# Volcano Heights Sector Development Plan

## Open Space & Recreation Meeting

March 27, 2012

### Questions/Concerns/Comments

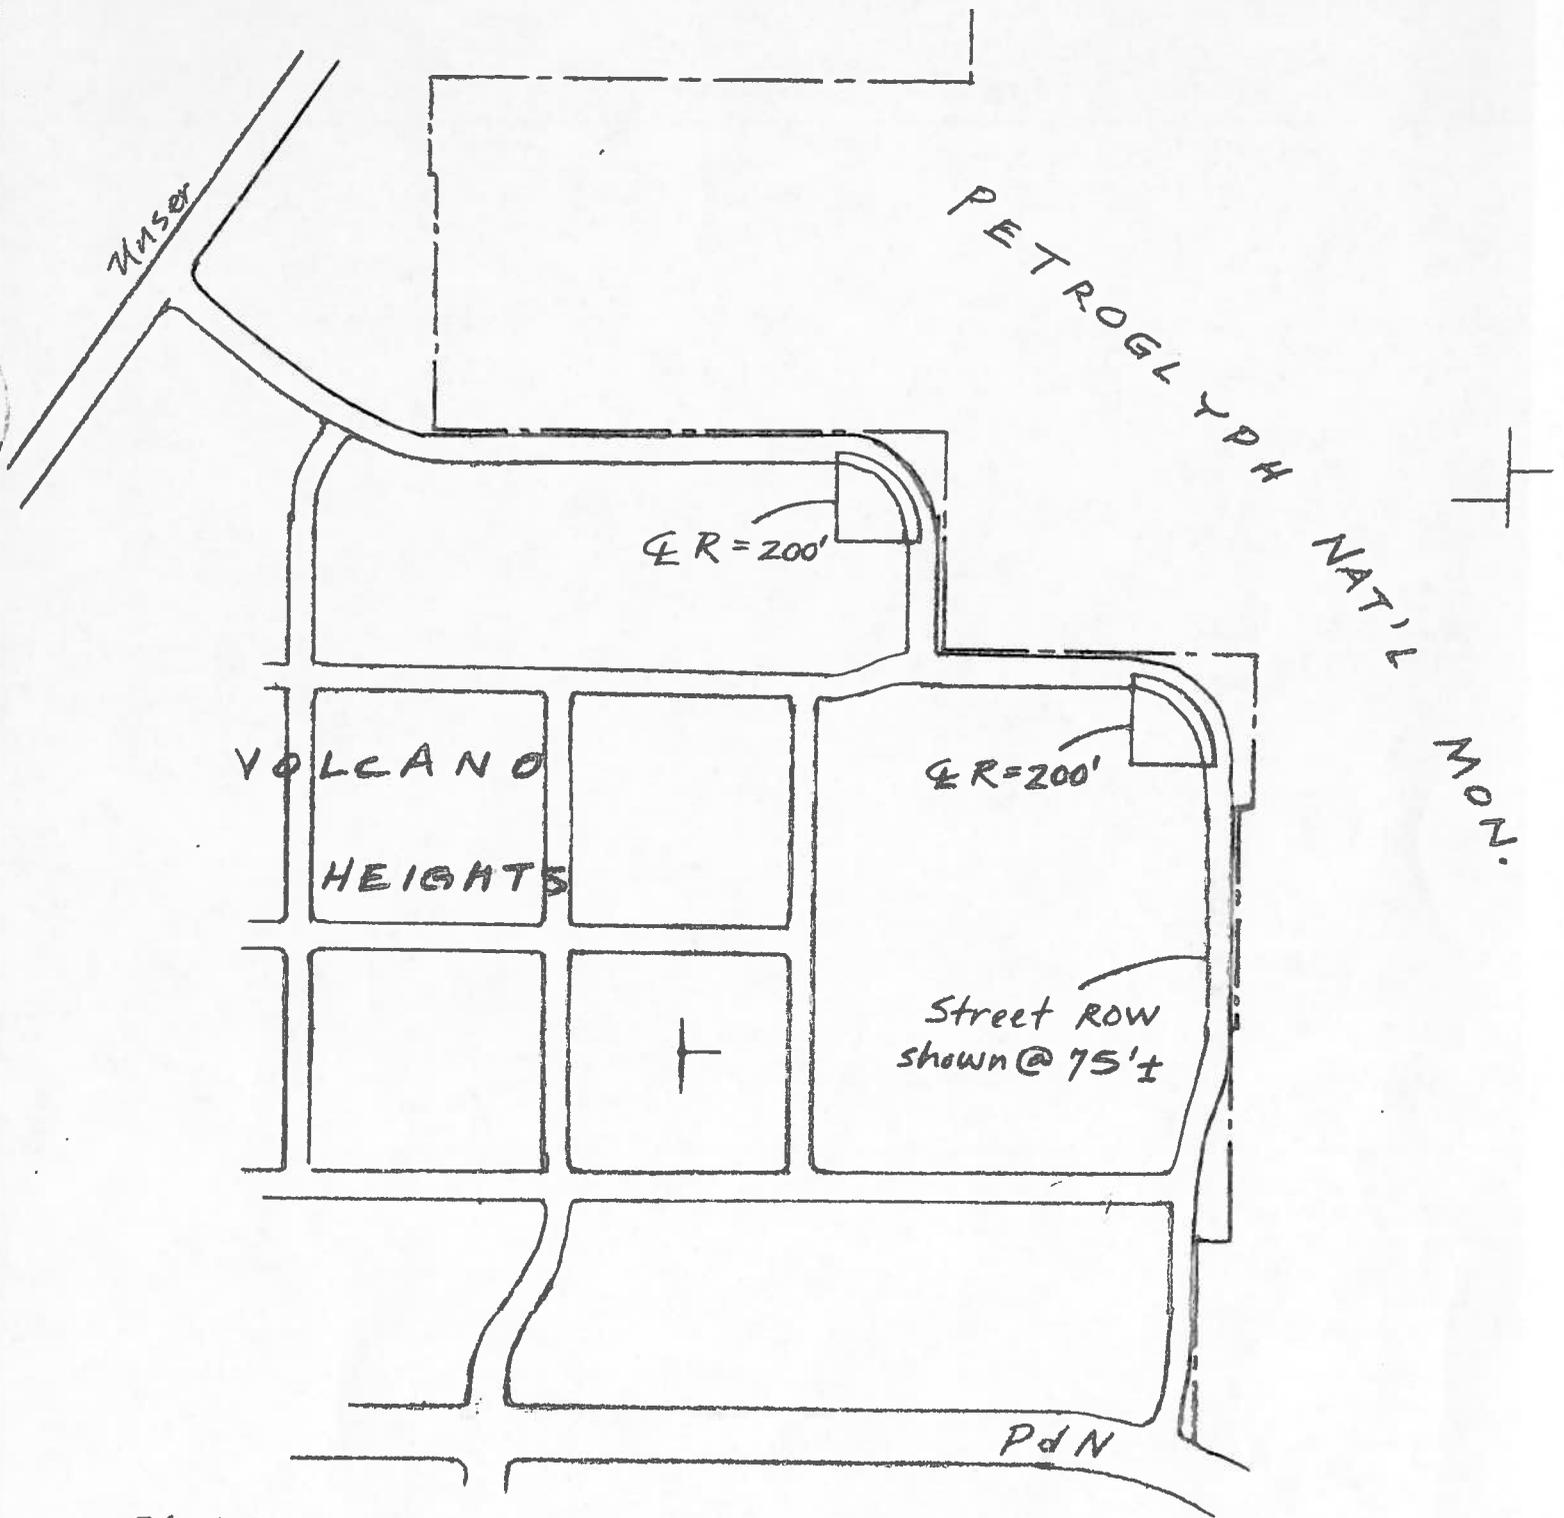
- Neighborhood Transition zone on the northern boundary should be extended east abutting the school, as was shown in previous draft zoning maps.

Sketch of Street Bordering Petroglyph Nat'l Mon.

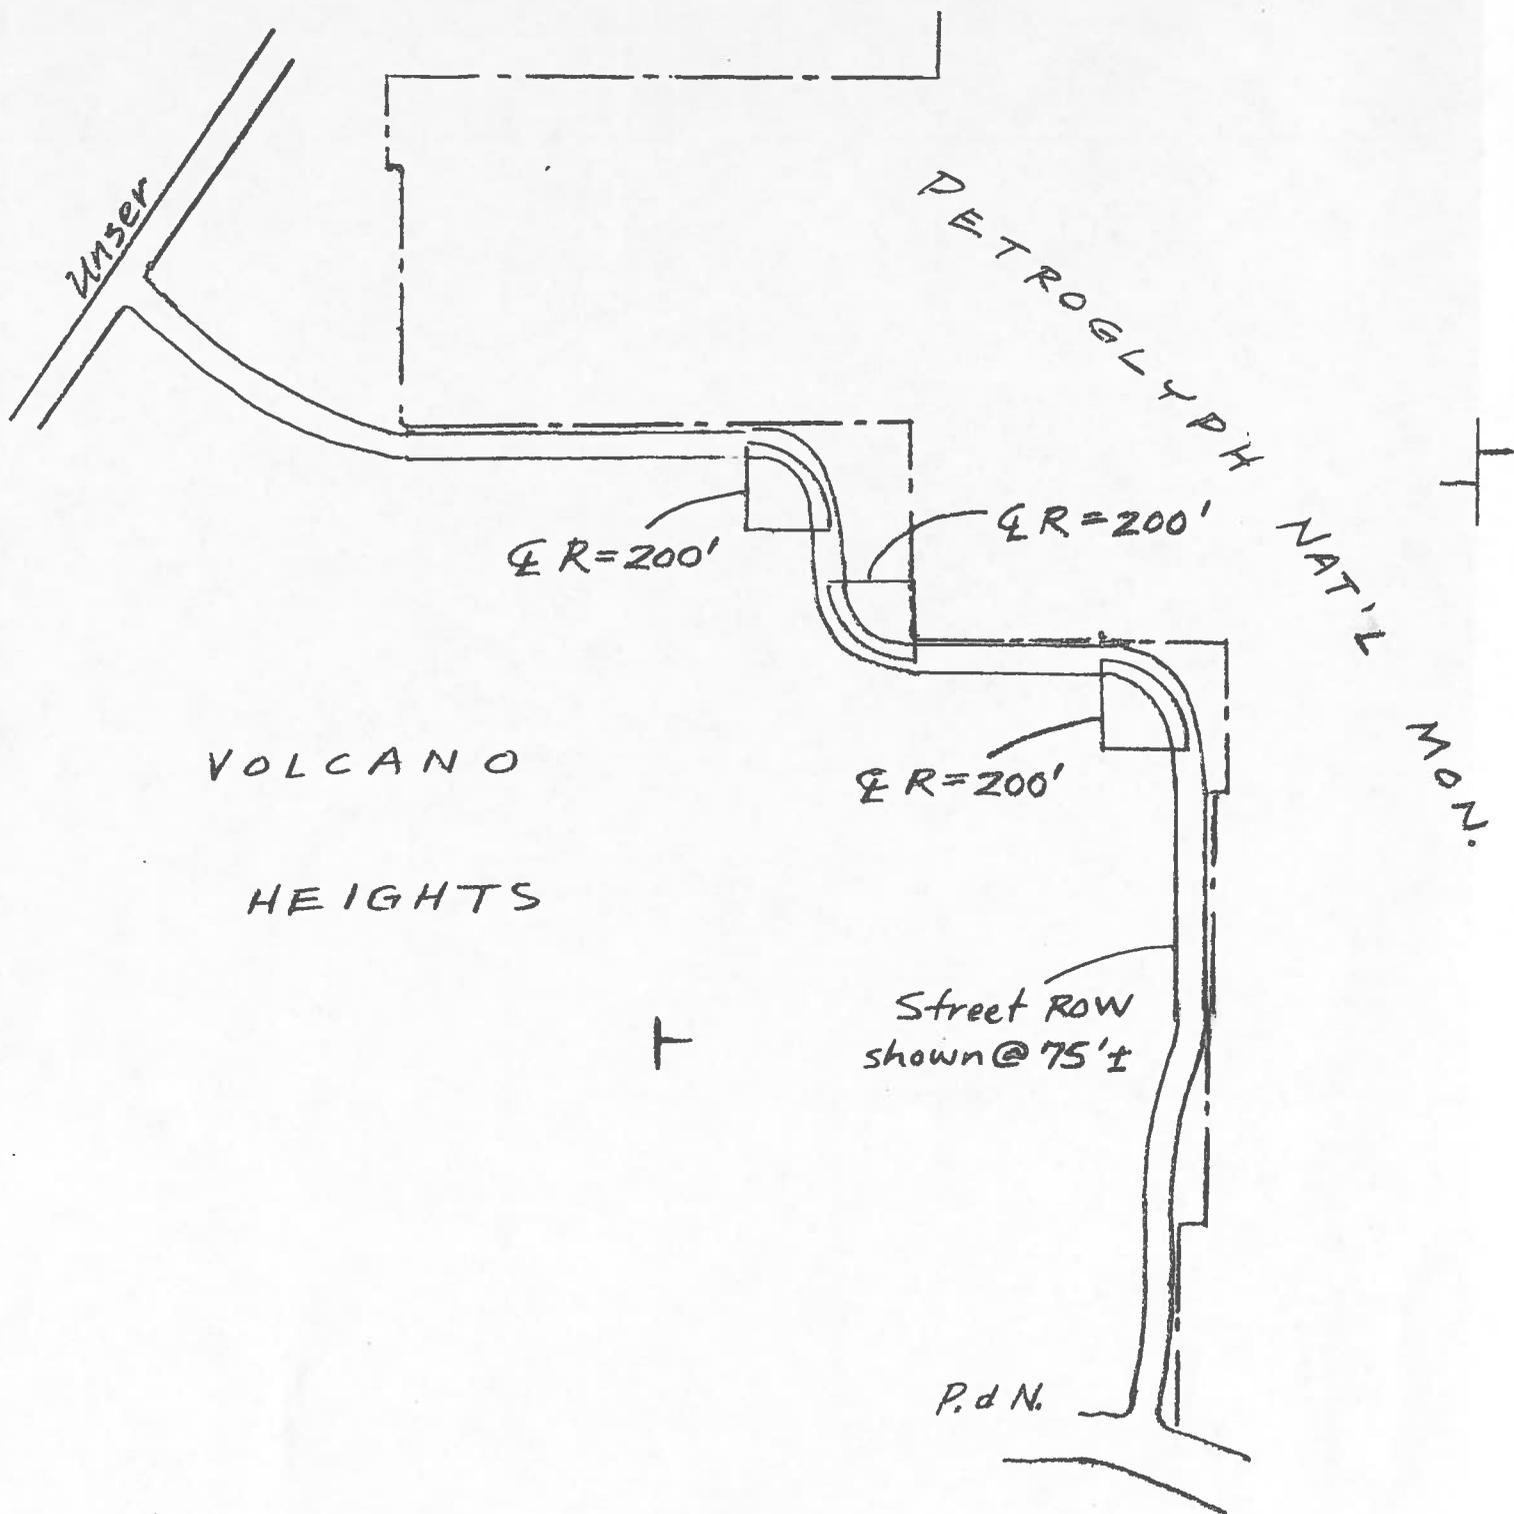
- Park Edge road should be moved to provide more single-loaded street abutting the monument. See attached sketches.
- Is it possible for streets to be ‘A’ Streets on one side and ‘B’ streets on another? What happens if a property is too small to meet the required ‘A’ vs. ‘B’ percentages?

CONCEPT 2 - Tighter Curves same as Concept 1, but Street and nearby streets re-aligned.
